Addendum No.: 1

Bid#: 24-10-2

Project Name: Highway LA-21 Lift Station

ELECTRICAL PLAN

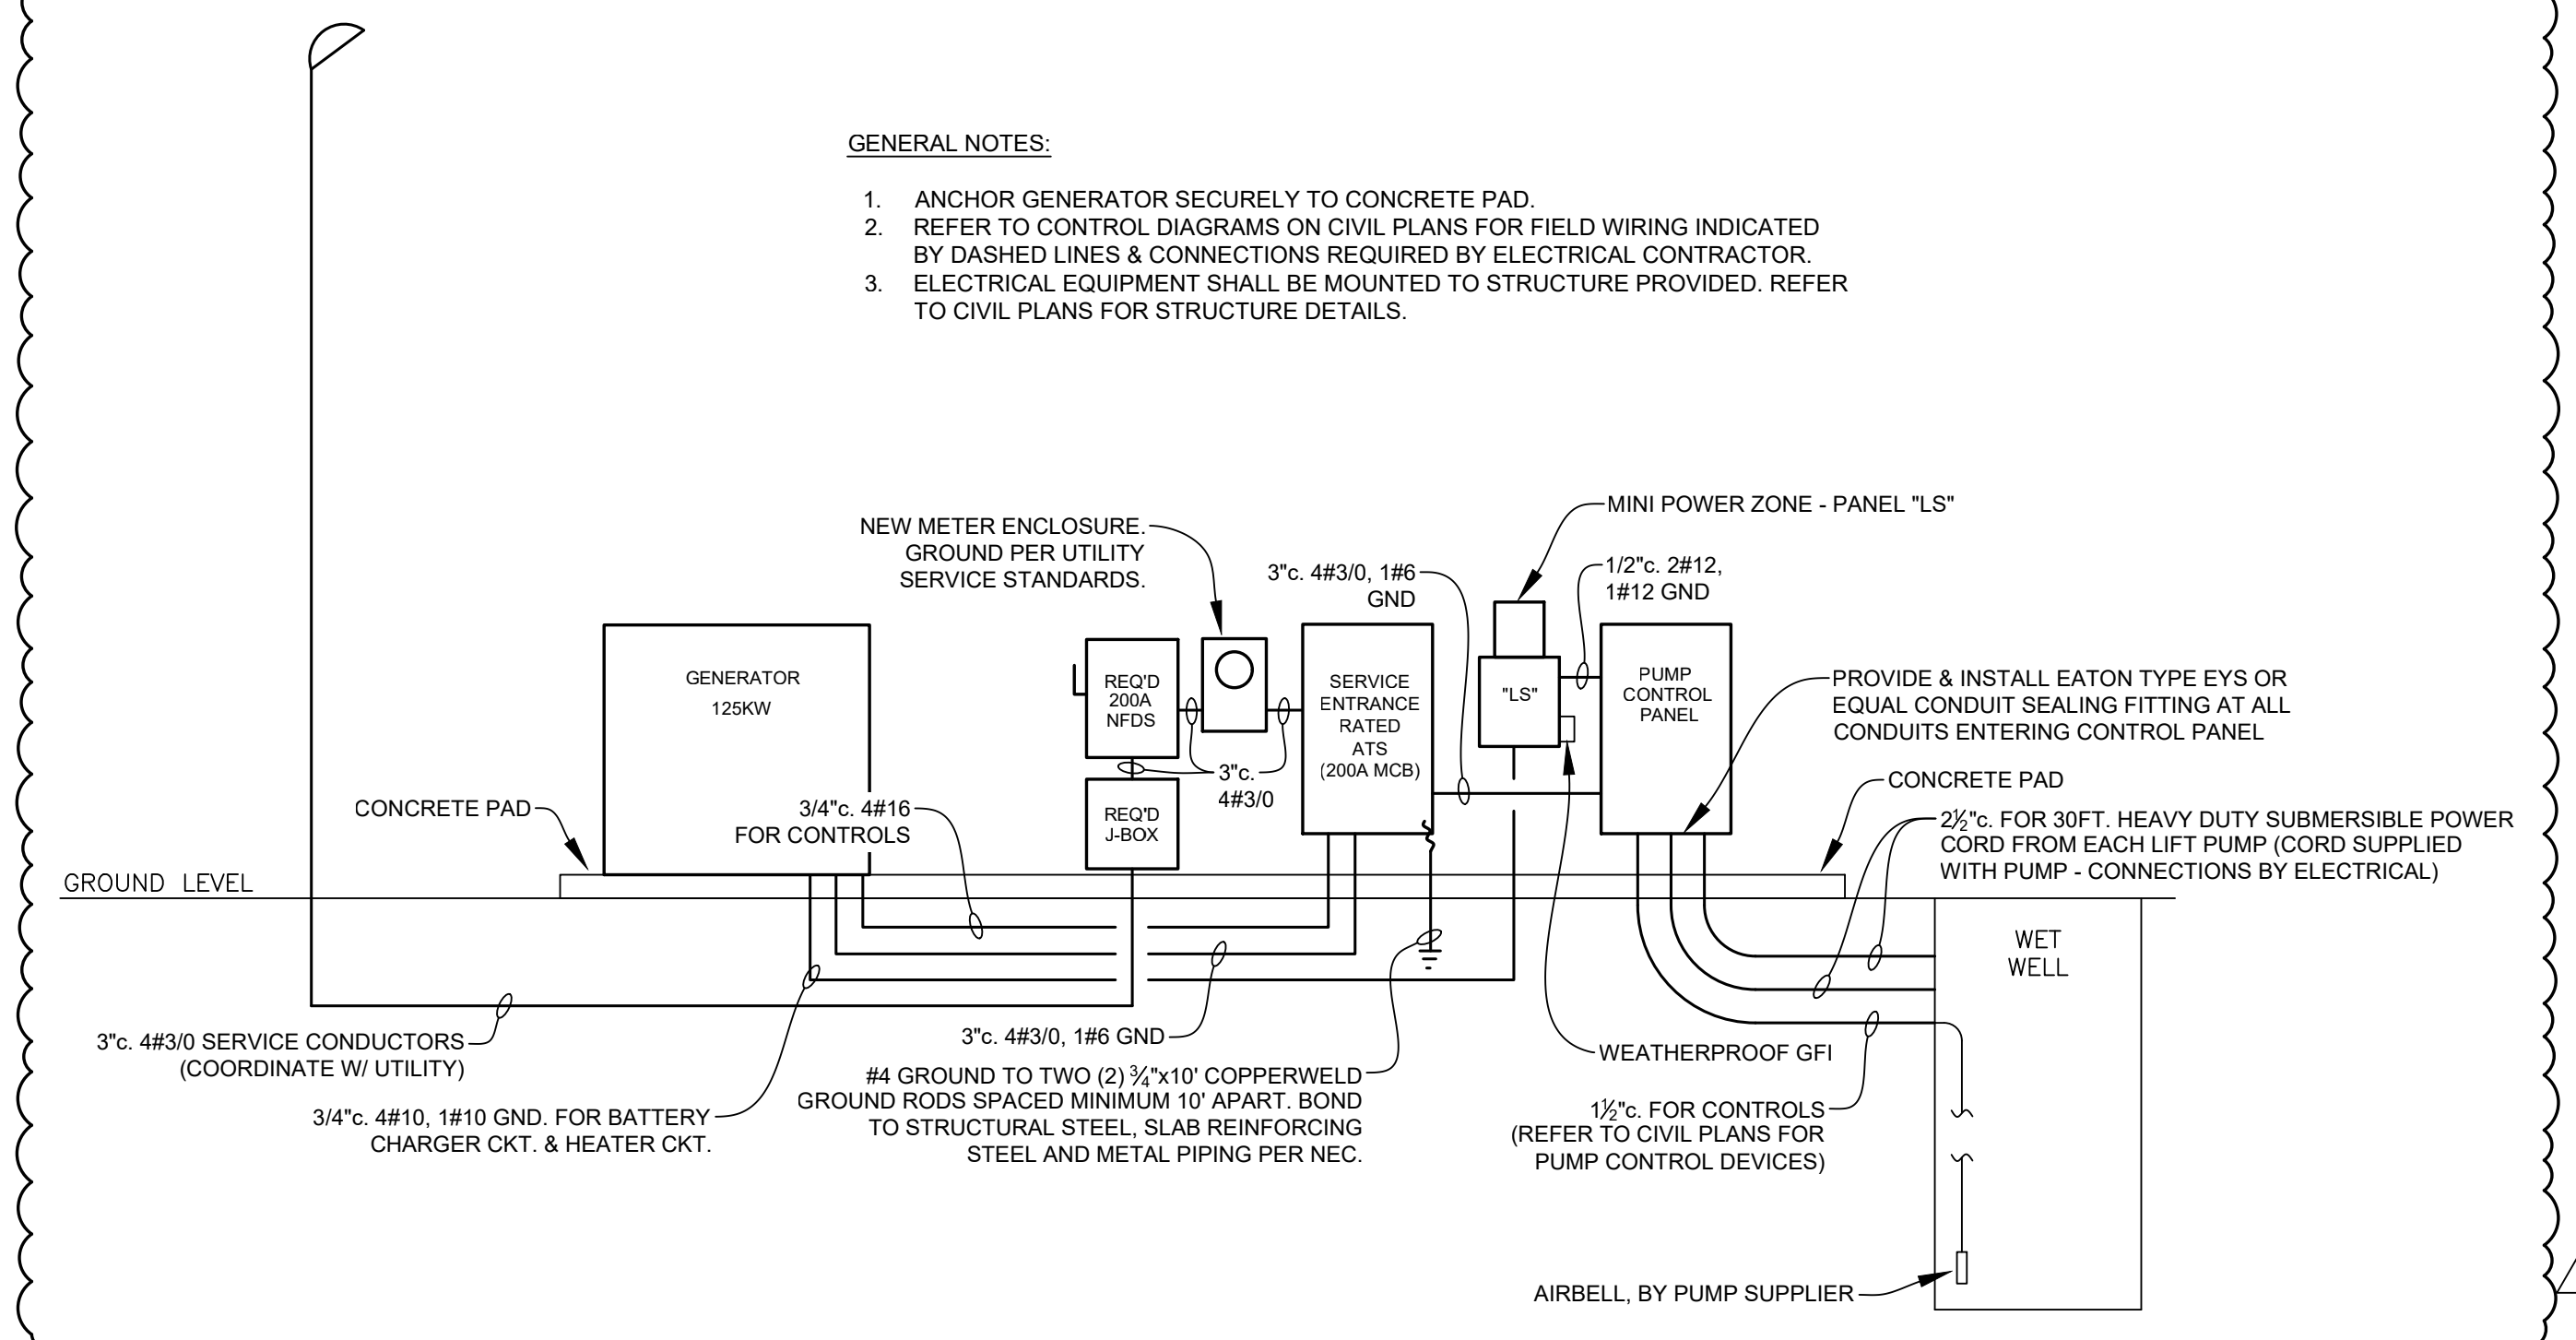
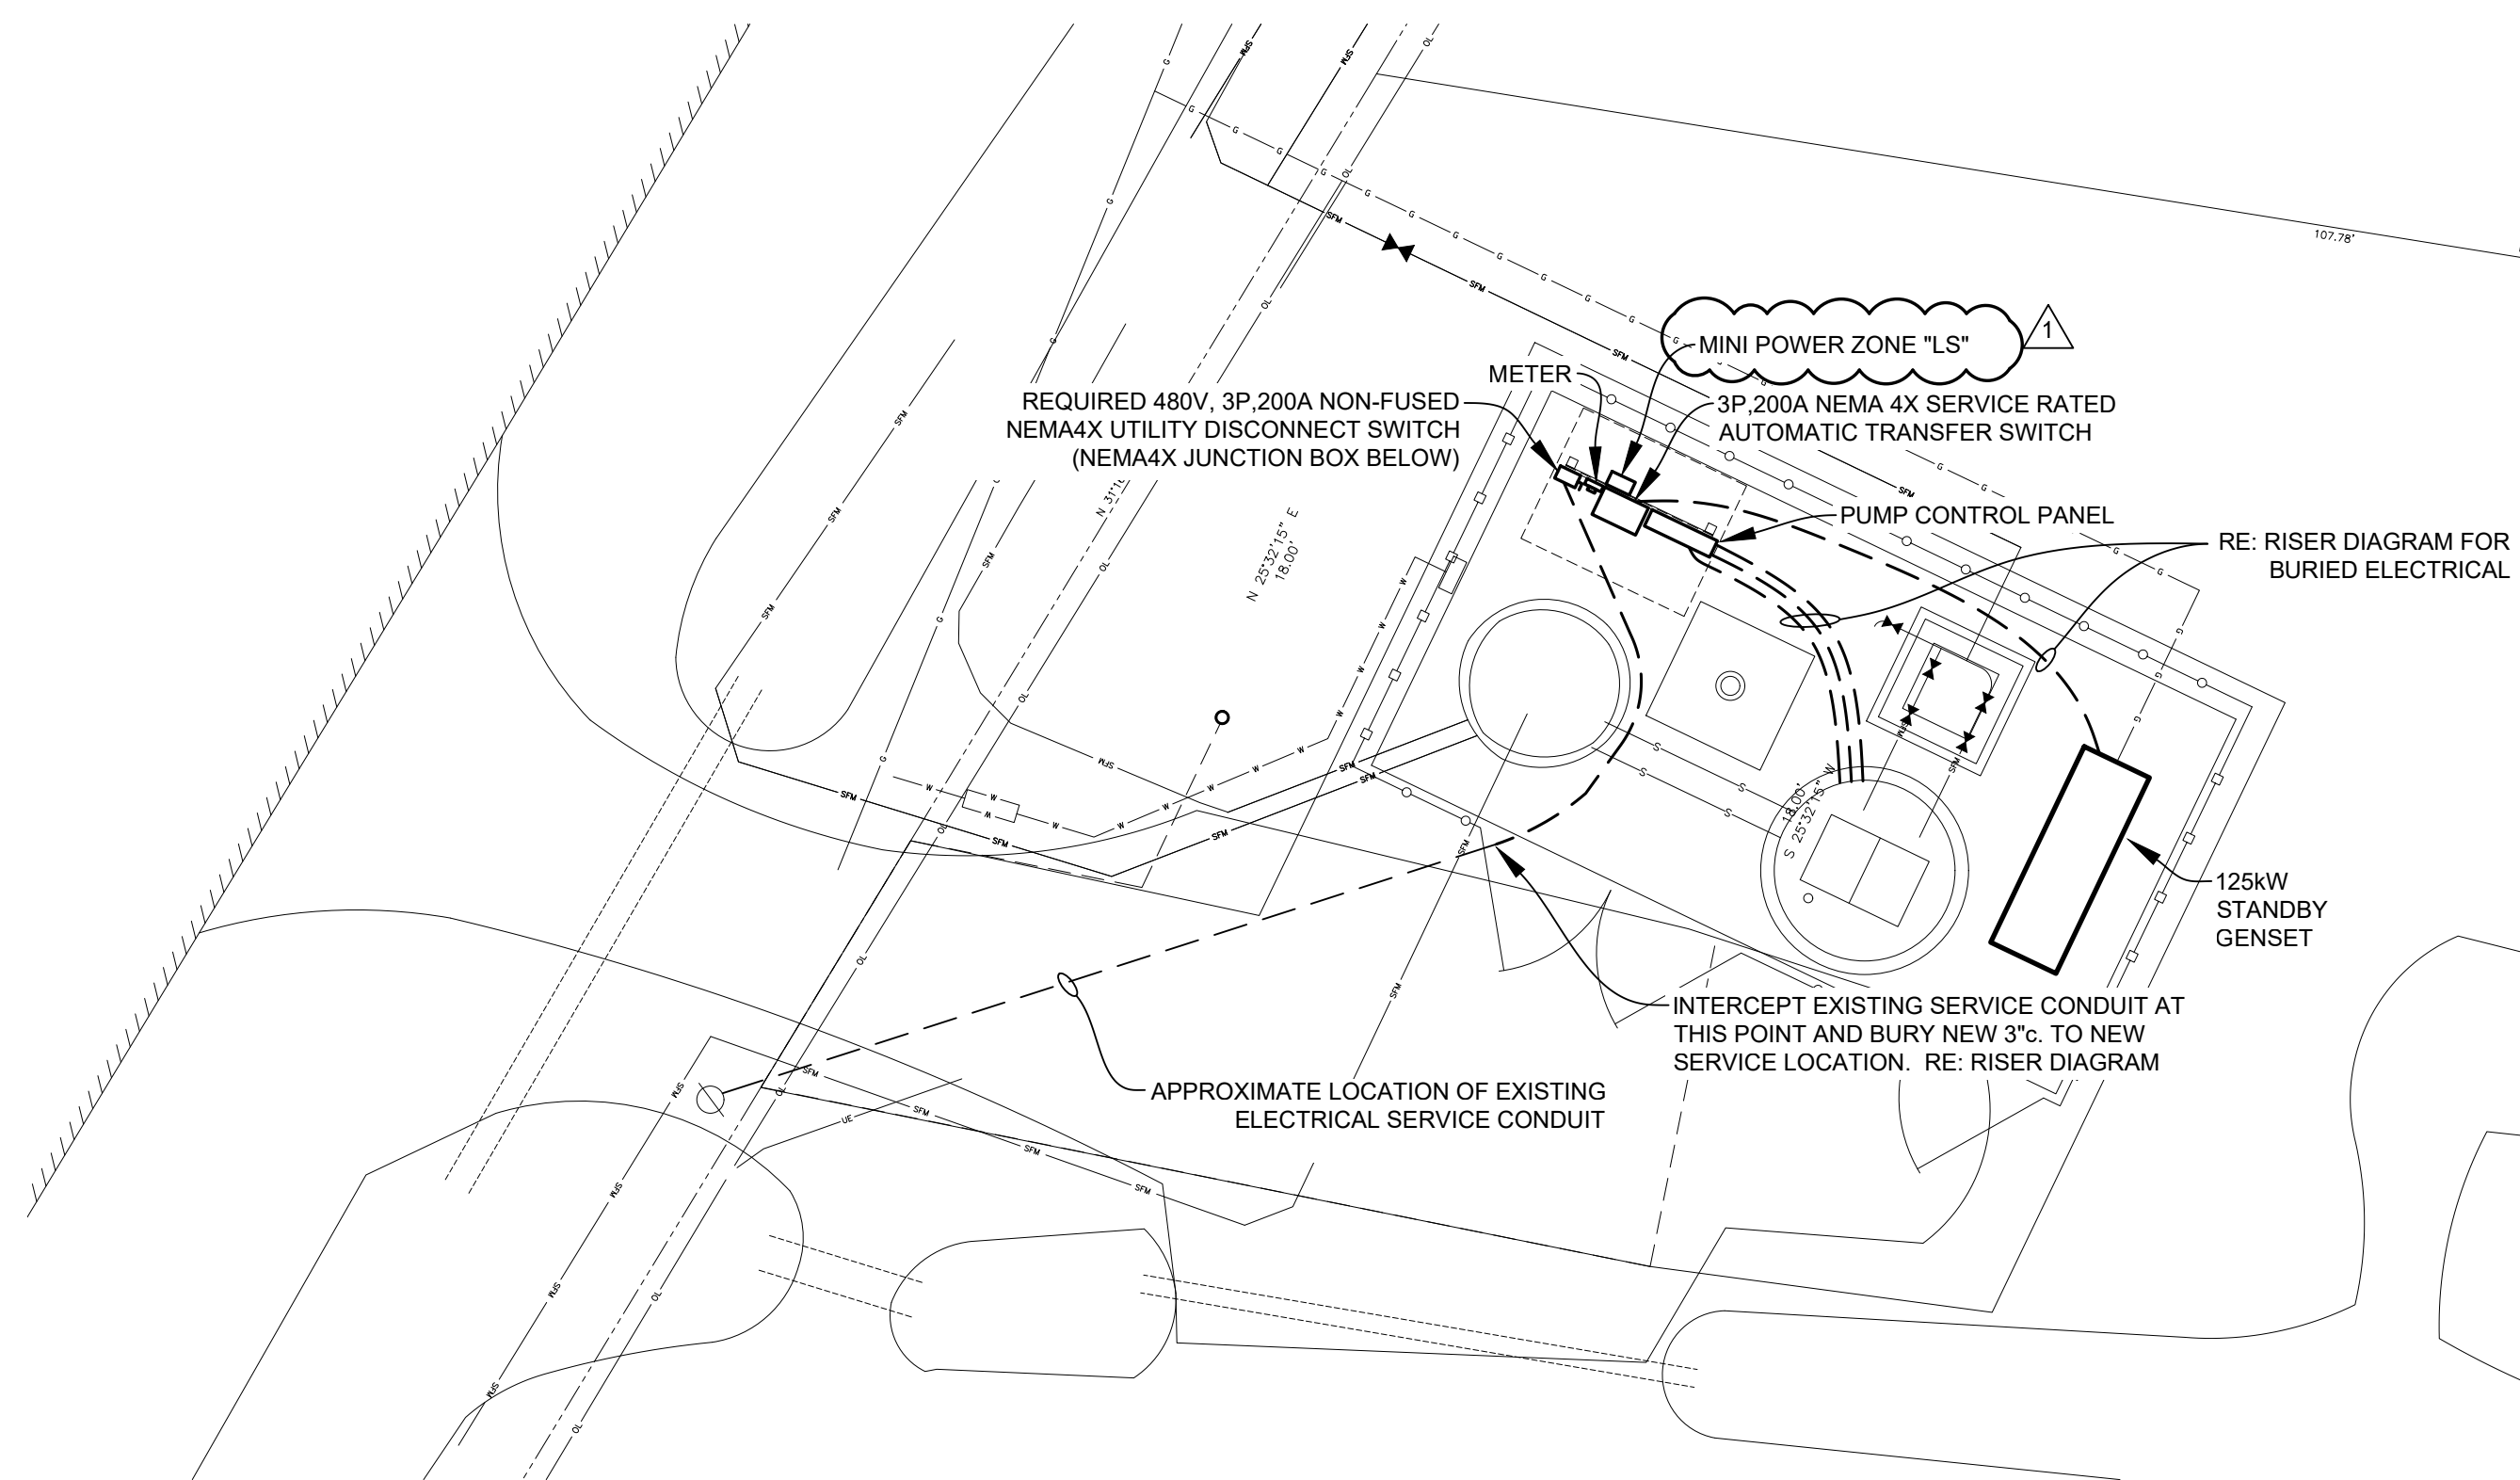
Drawing Clarification: Sheet 46 – Electrical Plan has been revised to revise calls on the ‘Riser Diagram’ and add a table for the control panel. See Sheet 46 – Electrical Plan for more details, in this Addendum below.

6. Sheet 46 – Electrical Plan:

- Add table for ‘Panel: “LS”’
- Revise conduit call from Pump Control Panel to Wet Well
